## REMARKS

Appl. NO. 09/836,104  
Amtdt. Dated November 30, 2004/11/30  
Reply to Office action of September 10, 2004/11/30  
Annotated Sheet Showing Changes

Fig. 1 (PRIOR ART)

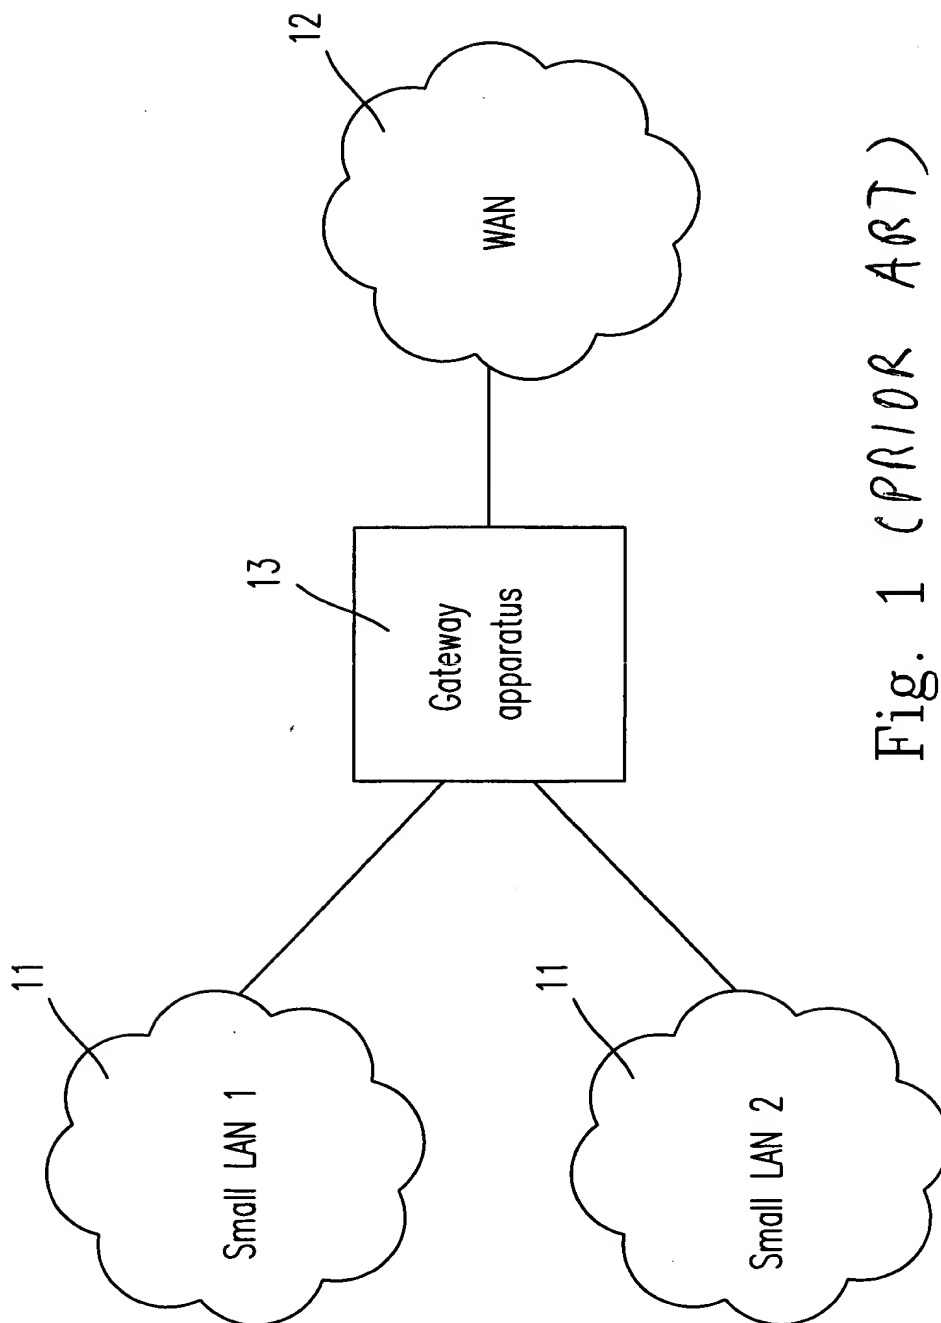
Figs. 1 and 2 were objected to as the legend should include a designation, such as Prior Art. Figs. 1 and 2 have been changed accordingly.

The attached sheets of drawings includes changes to the legends of Figs. 1 and 2. These sheets, which includes Figs. 1-2, replace the original sheets including Figs. 1-2.
